Agenda – Riel Community Committee – October 19, 2016

**Item No. 5 Variance – 825 Taché Avenue
(St. Boniface Ward)
File DAV 135803/2016D [c/r DASZ 34/2016 & DAC 13/2016]**

Title: DAV 16-135803\D – 825 Taché AVE

Issue: For consideration at the public hearing for variances associated with the construction of a multi-family building, a two-family dwelling and two mixed-use buildings zoned “RMU”.

SITE PLAN
825 TACHE
07/06/2016

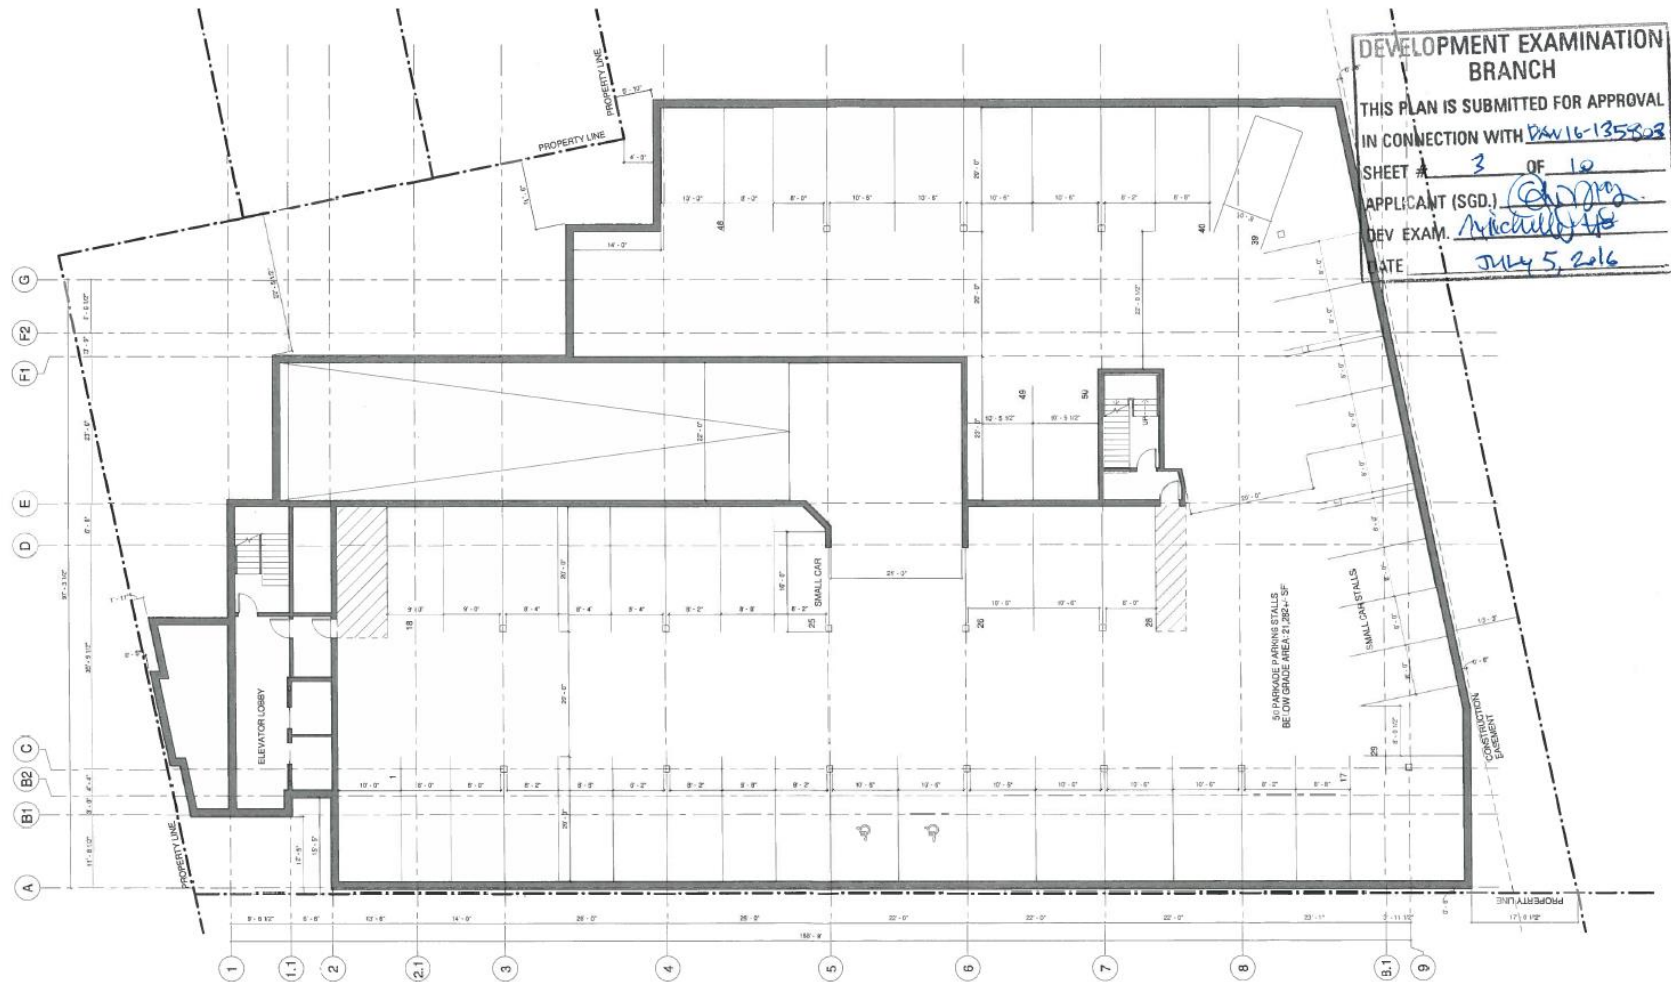
- The Urban Planning Division is supportive of permitting the multi-family building to be erected on the north property line instead of being set back 20 feet for the following reasons:

- The Urban Planning Division is supportive of permitting a south corner side yard of 11 feet instead of 20 feet for the following reasons:
 - This variance is taken from the potential future rapid transit corridor lot line and not from the rue Darveau lot line. If measured from the rue Darveau, the building would actually have approximately an 18 metre setback; and

- The Urban Planning Division is supportive of a variance as modified for a 12 foot rear yard to the principal building and balconies instead of 25 feet for the following reasons:

- The Urban Planning Division is supportive of the reduced front yard variance (10 feet instead of 20 feet) for the following reasons:
 - This proposed setback is line with the adjacent properties;
 - The geometry of the lot (28 feet by 90 feet) is smaller than the typical lot within the City of Winnipeg and this neighbourhood. As such, some flexibility is required to accommodate the development that fits into the character of the existing street.

- The Urban Planning Division is supportive of a reduction in parking stalls for the uses on the site for the following reasons:
 - There are approximately 108 on-street parking spaces available within the Pointe Hébert neighbourhood. This parking total number takes into account parking inefficiencies associated with parallel parking. Of the 108 parking spaces, approximately 20 on-street parking spaces are available on avenue Taché. All of these spaces have a one (1) hour restriction on them Monday through Saturday between 9h00 and 15h30. This will provide sufficient turnover rate for the two (2) commercial store fronts as part of the project. Overall, there are about 48 single

- The Urban Planning Division is supportive of the variance for no south corner side yard instead of 20 feet to the accessory parking for the following reasons:

- The Urban Planning Division is supportive of no north and south interior side yard instead of 5 feet for the following reason:
 - That it provides a landscaping island within the parking area that provides an opportunity to soften the concrete views in the accessory parking lot area.

- The Urban Planning Division is supportive of parking spaces within 10 feet of a window to a habitable room where the sill is located 5 feet or less from grade for the two-family dwelling for the following reason:

- The Urban Planning Division is supportive of the insufficient landscaping on the rue Hébert frontage for the following reasons:
 - Because the applicant is proposing a zero lot line for the multi-family dwelling; and

- The applicant is proposing to plant the equivalent requirements within the newly created PR1 lands.
- The Urban Planning Division is not supportive of the insufficient landscaping variance along the rue Darveau frontage for the following reasons:

- There is no hardship to the applicant in meeting this requirement; and
 - Providing the landscaping requirements will help to delineate between private and public space. This is important because rue Darveau will act as one of the primary access points to the Red River in the Pointe Hébert neighbourhood. When there is a lack of delineation between public and private space the Administration’s experience is that private landowners tend to encroach upon City land. Providing this delineation through a combination of trees and shrubs will help to mitigate these concerns.

The Urban Planning Division recommends **approval as modified** of the application to vary the proposed "RMU" Dimensional Standards of Zoning By-law No. 200/2006 as follows:

- 6) for the establishment of insufficient street edge landscaping along the north side facing Hebert St. ~~and the south side facing Darveau St.~~
